HENDERSON COUNTY BOARD OF COMMISSIONERS

SUBJECT: Widening of the Transfer Station Entrance Road

Project: 241017 - Henderson County - Transfer Station 3rd Bay Project & Tipping Floor Replacement
 802 Stoney Mountain Rd.
 Hendersonville, North Carolina 28791

Prime Contract Change Order #002: Entrance Road Widening

Proposed Widening Transfer Station Drive

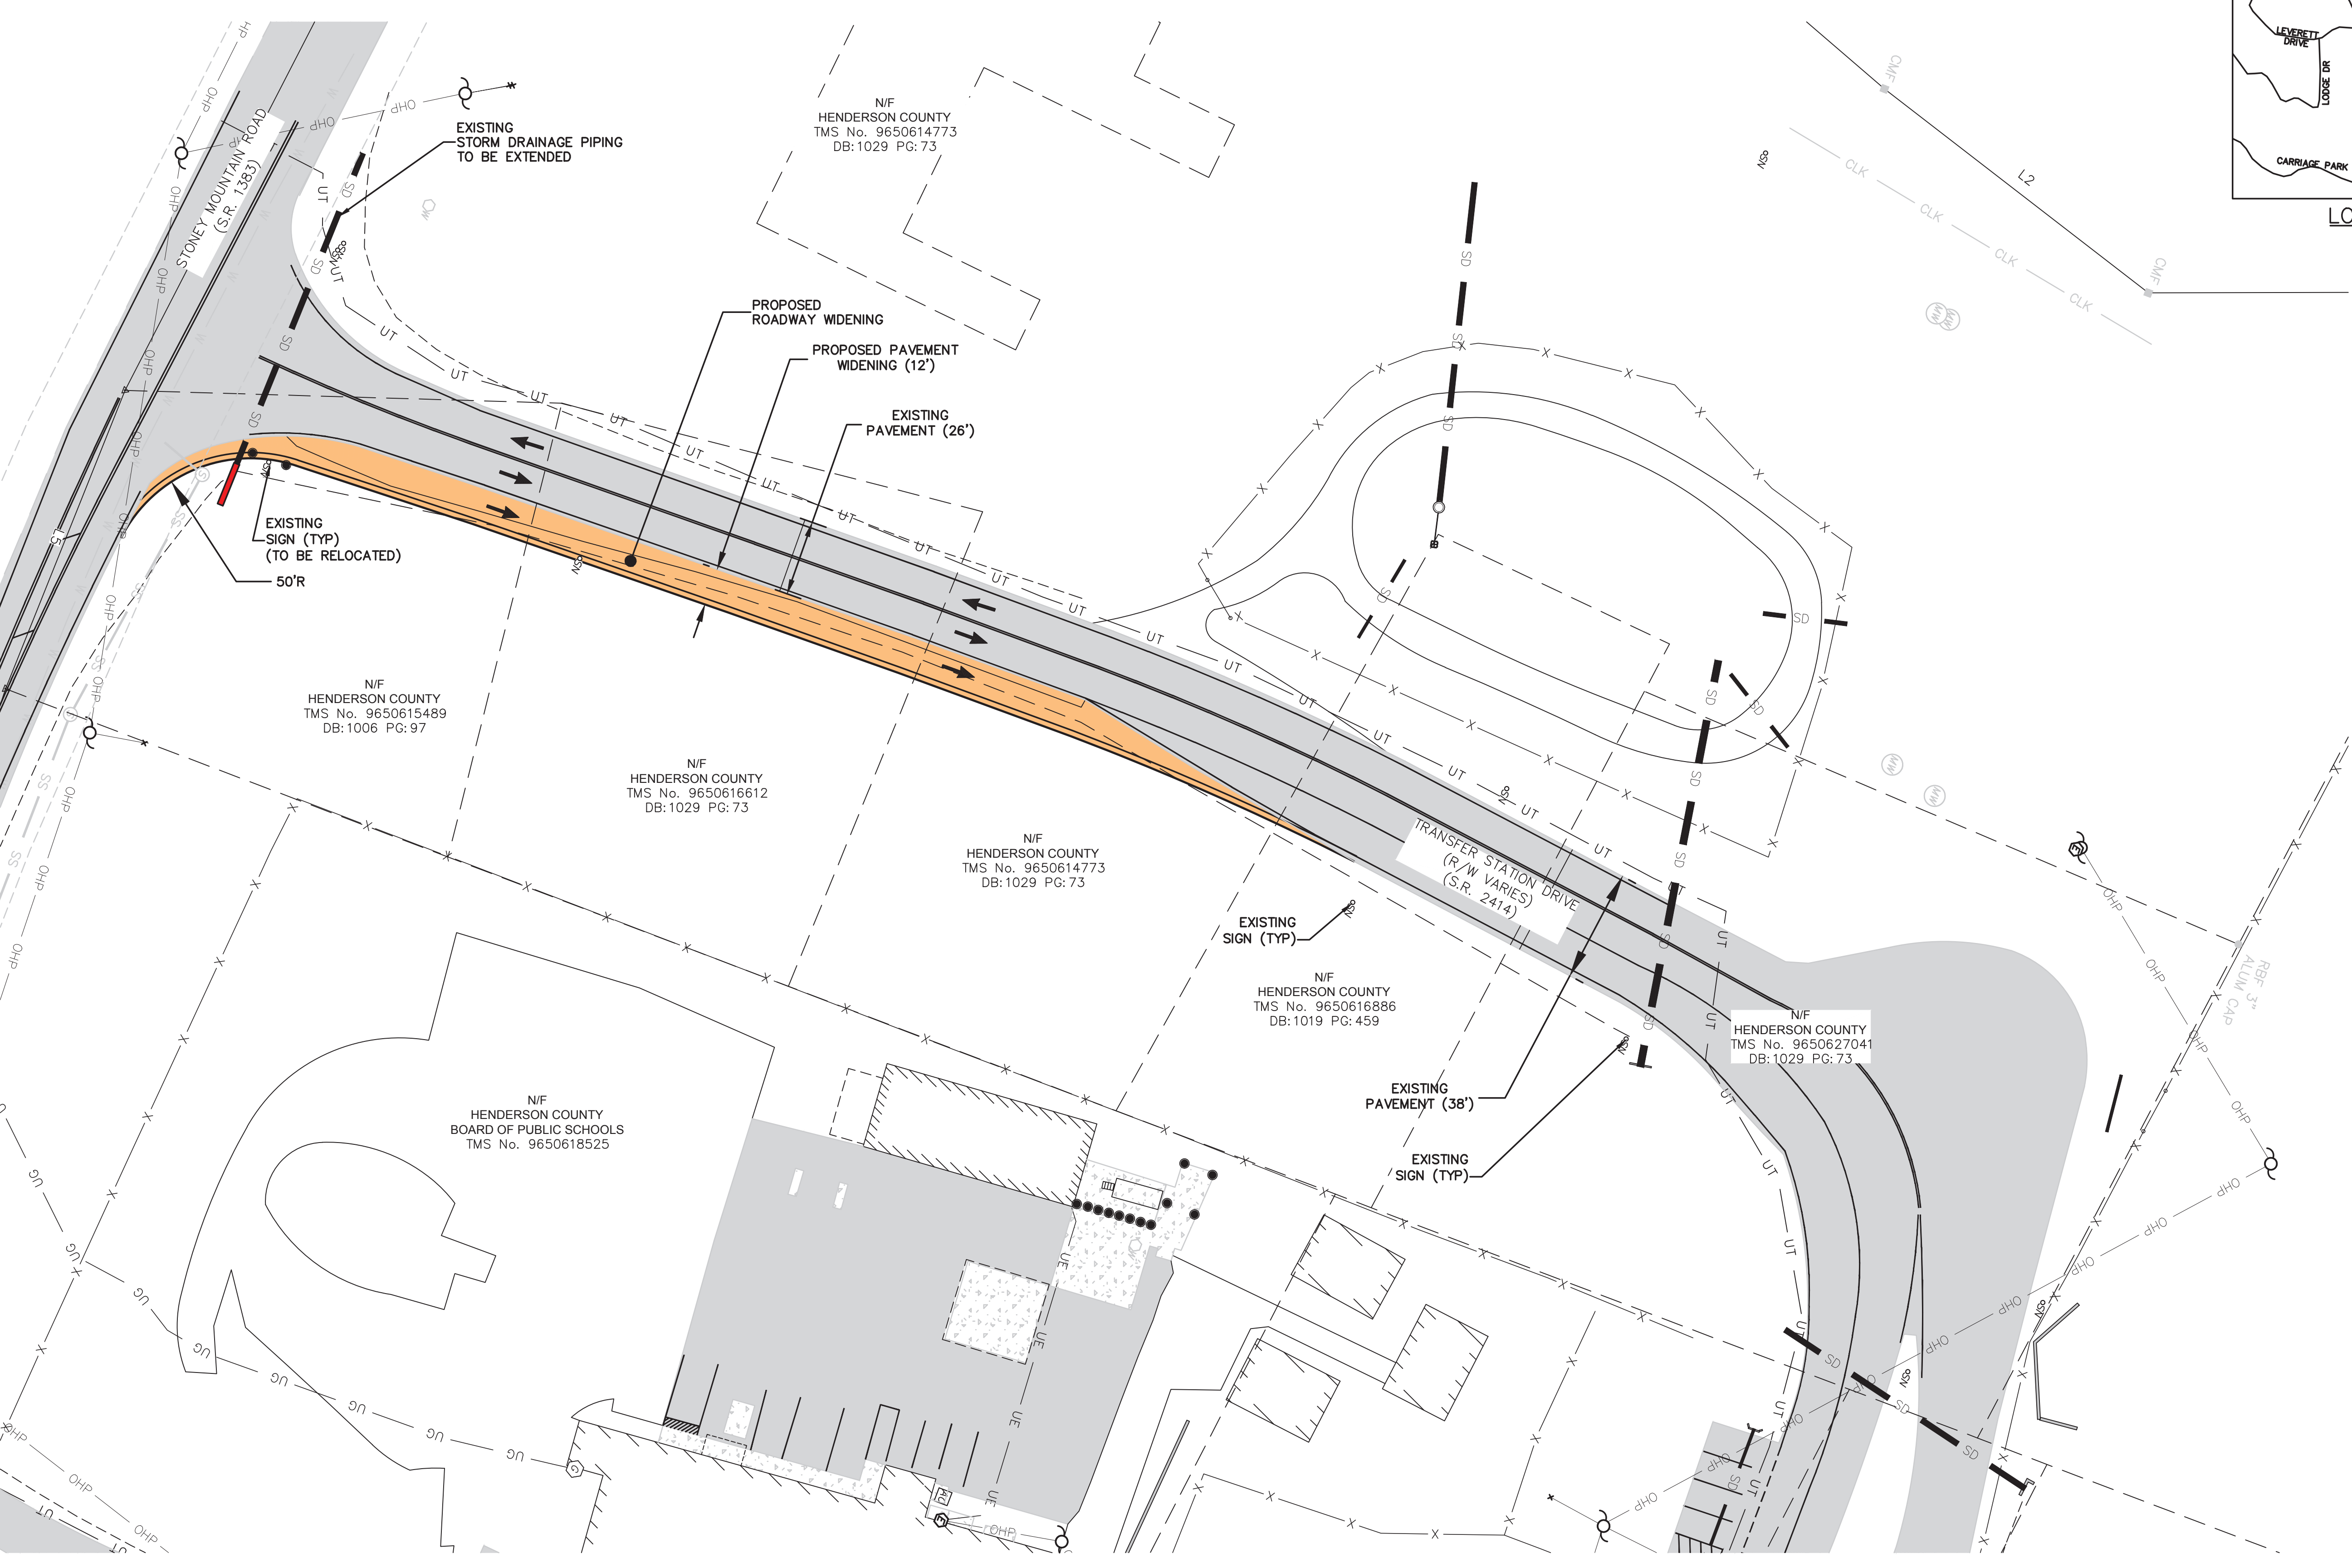
- Pricing is based off documents provided by WGLA Engineering dated 3/24.
- Pricing does not include asphalt overlay of existing asphalt
- Pricing is based on working during regular business hours
- Pricing includes \$10,000 allowance for flagging services to help reduce the impact to Transfer Station operations
- Pricing includes \$5,000 allowance for additional striping/signage.
- Pricing includes a \$12,000 allowance for use to remediate potential unsuitable soils.
- Pricing includes a \$5,000 allowance to relocate the sign.
